**CITY OF LOUISVILLE  
STARK COUNTY, OHIO**

**METZGER PARK BASEBALL & SOFTBALL FIELDS**

**ADDENDUM #1**

**THRASHER PROJECT #101-T30-11111**

UNDER DRAIN & PLAYERS BENCH DETAIL

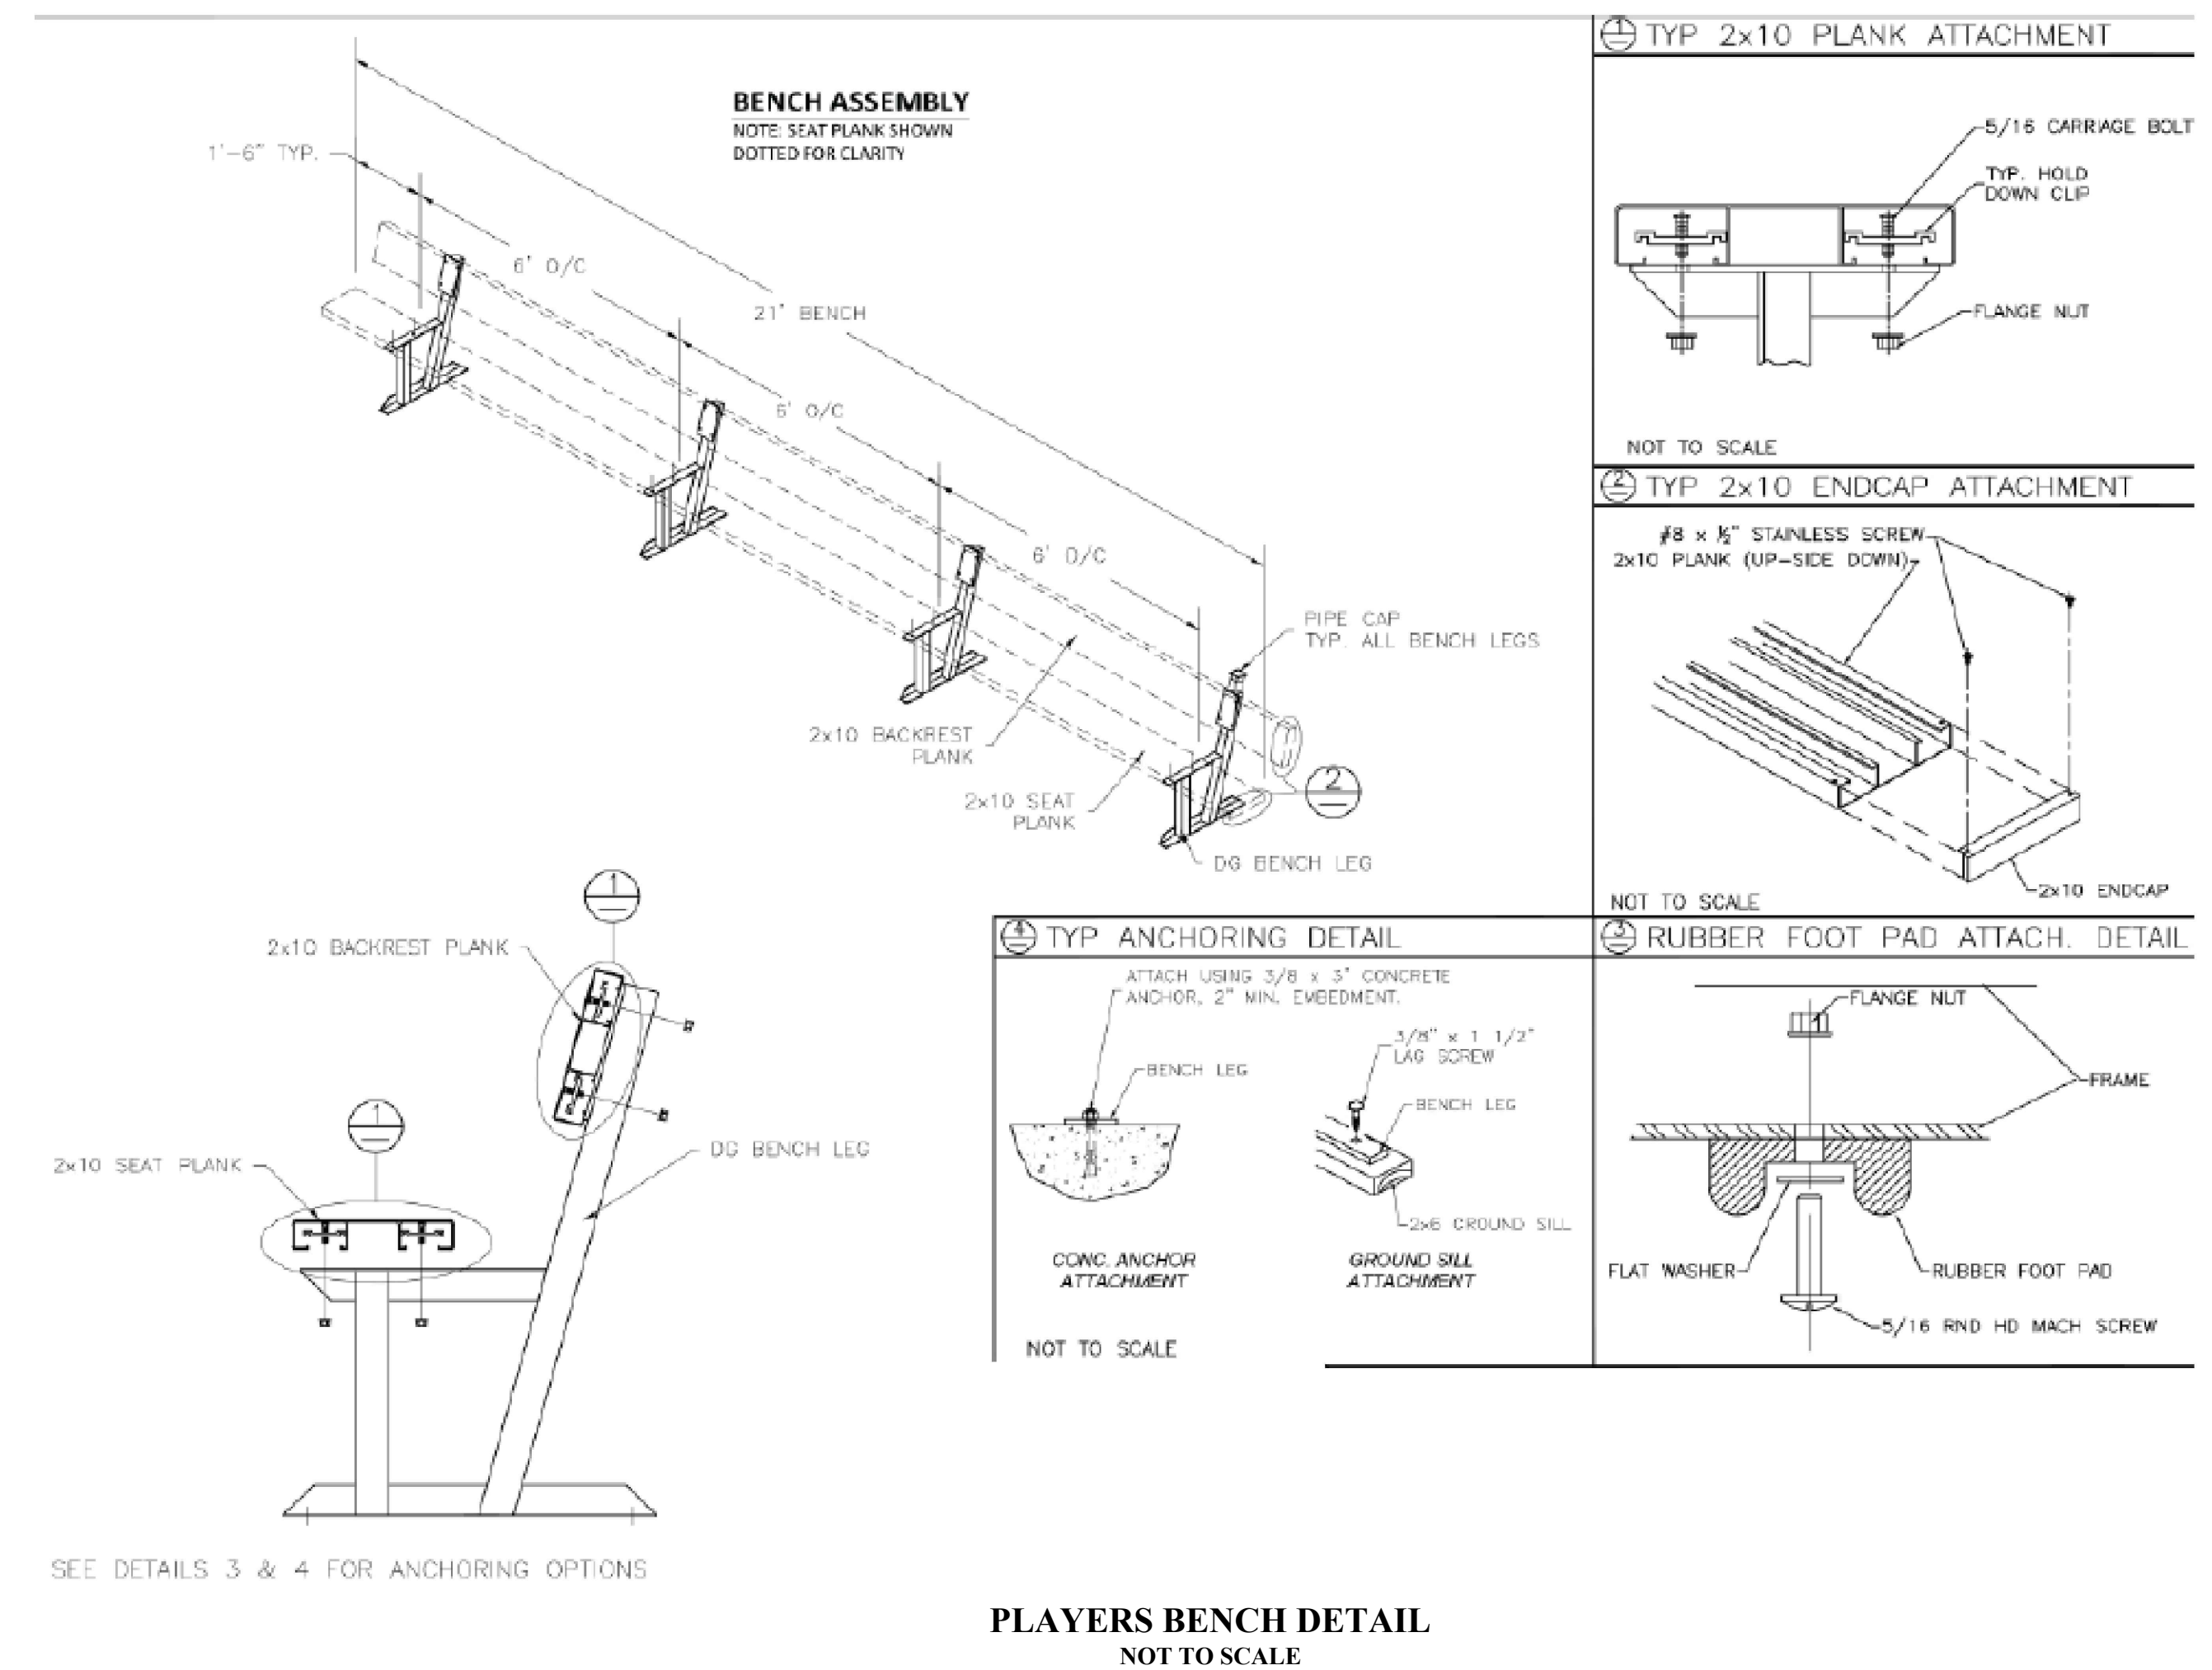
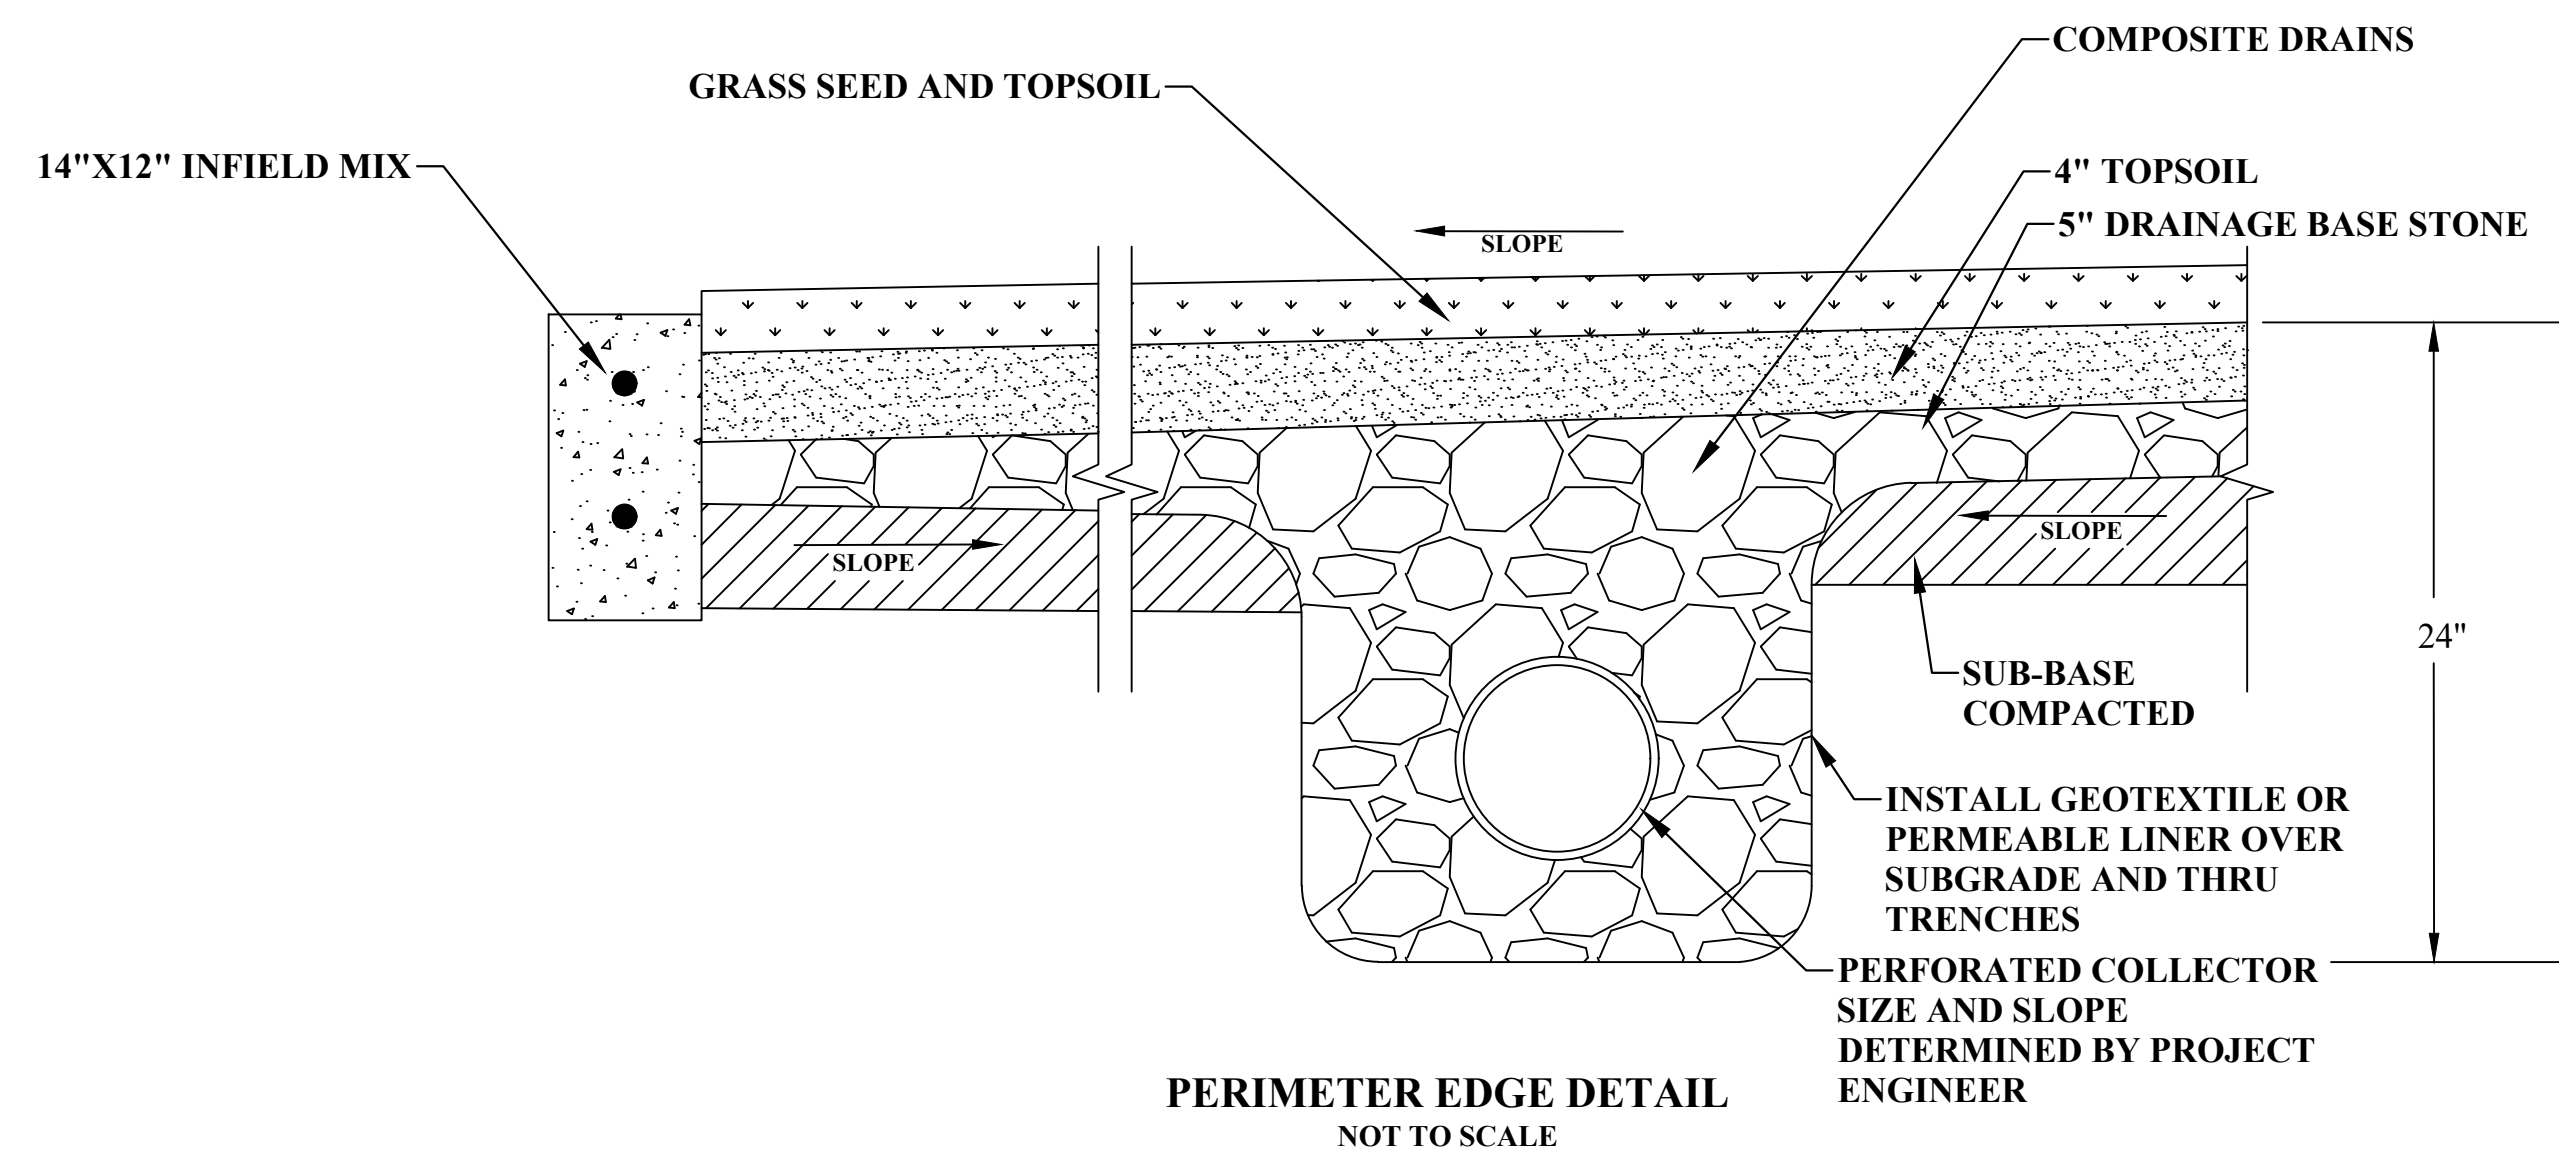
- a. Referencing the "EDGE DETAIL (isometric view)" 14"x12" Infield mix - with the FIELD DRAINAGE NOTES: #2 "A NEW CONCRETE CURB AND NAILER WILL BE INSTALLED AROUND THE PERIMETER TO PROVIDE A SECURE EDGE TO STOP FIELD MIX MIGRATION" There is no allocation on the BID SCHEDULE. Is this item to be considered a non-perform item?

- b. Referencing the "EDGE DETAIL"(both views) It Appears that the geotextile fabric would extend to encompass the entire subgrade of the infield only. If that is the case, can an itemized quantity per field be provided? As well as a specific fabric?

**The outer edges of the infield mix have no concrete curb. Updates have been made to field drainage note number 2.**

**The geotextile fabric has been provided in the Bid schedule.**

2. NAILER WILL BE INSTALLED AROUND THE PERIMETER TO PROVIDE A SECURE EDGE TO STOP FIELD MIX MIGRATION. IN ALL CASES THE NAILER AND STONE ARE AT THE SAME ELEVATION.
